**WOODLAND HEIGHTS SUBDIVISION**

**NEW FAIRFIELD, CONNECTICUT**

**King's Mark  
Environmental  
Review Team  
Report**

March 1993

**CONSTRUCTION SEQUENCE**

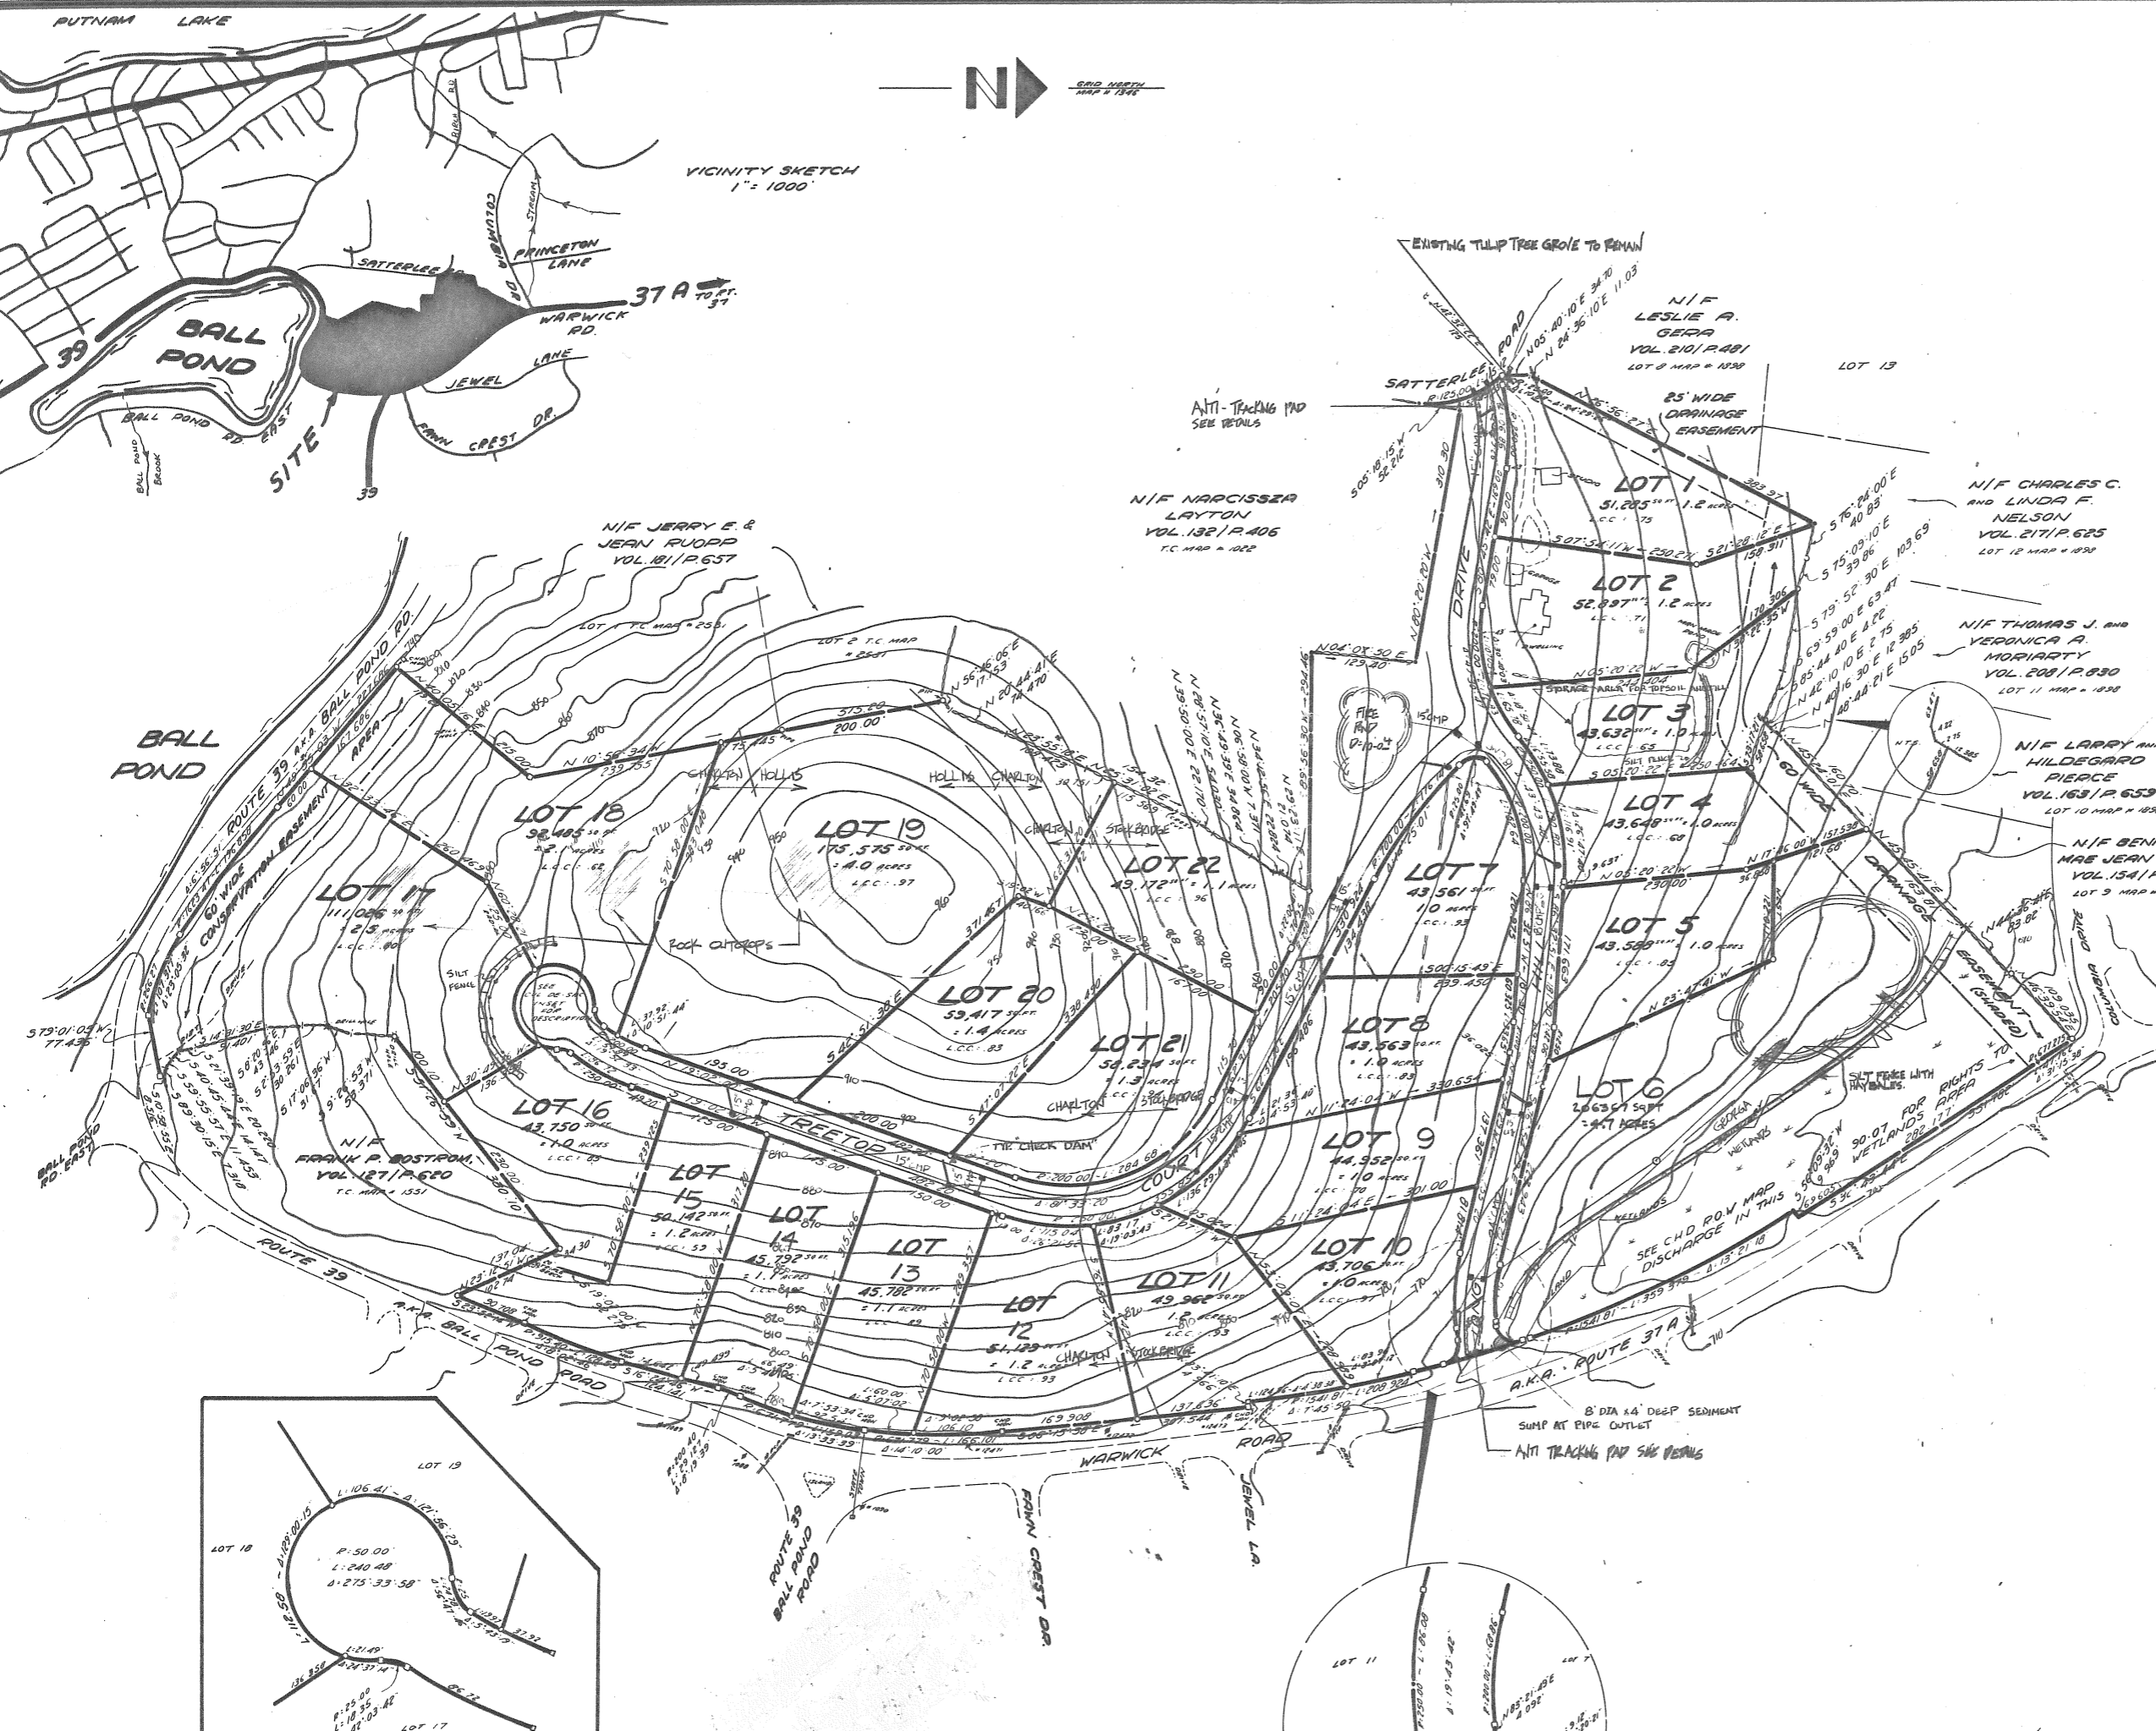
1) The proposed detention basin is required to keep post-development runoff at or below pre-development runoff. The detention basin as designed accomplishes this, based upon assumptions and methods used by the designers. However, the criteria used for design differs from that of the "Connecticut Guidelines for Soil Erosion and Sediment Control". For example, the detention basin is classified as an embankment detention basin. Therefore, the minimum top width of the embankment should be 8.0 feet, not 4.0 feet as shown on the plans. Also, the combined upstream and downstream side slopes of the settled embankment should not be less than 5:1, with a maximum slope steepness of 2:1. The plans show a combined side slope of 4:1.

Additionally, the minimum capacity of the detention basin's emergency spillway shall be that required to pass the peak flow expected from a design storm of 100-year frequency, 24-hour duration, type III distribution. The method the designers used did not reflect this type of model storm. Also, the required freeboard shall be 1.0 feet above the water surface in the basin with the emergency spillway flowing at design depth. From the plans, only 0.5 feet of freeboard is shown.

Also, the plans show a foundation cut-off trench, but does not address the requirement of extending this trench up both abutments to a height equal to the emergency spillway crest elevation.

2) Water can be temporarily impounded against the detention basin at a height of 6 feet, as measured to the original low point in the dam at its centerline. Therefore, a CT Department of Environmental Protection Dam Construction Permit may be required.

3) The outflow structure for the detention basin is designed as a "Cipolletti" weir. The crest length of the weir as designed is 2 inches. It is recommended that a weir crest length of 3 to 4 times the head be used. This would imply that at a head of 6 feet, a weir crest length of 24 feet be used to justify using the "Cipolletti" weir flow equation. Instead, it might be more appropriate to use the flow equation for a V-notched weir, and re-compute the resulting stage/storage curves for the detention basin.

4) The plans show that all storm drainage will be conveyed through aluminum pipe. From the soil survey of Fairfield County, it indicates that the risk of corrosion for uncoated steel is moderate for Stockbridge and Georgia soils. This risk may be realized by aluminum as well.

Additionally, any direct contact between concrete and the aluminum pipe should be avoided to avoid deteriorating reactions of the two materials, such as what would be found at headwalls and catch basins.

5) Regarding the proposed fire pond, it would be desirable to install a dry hydrant to facilitate the operation of fire fighting apparatus.

6) Regarding the proposed rock riprap retaining walls, a filter blanket should be designed and installed between the riprap and the underlying soil surface to prevent soil movement into or through the riprap.
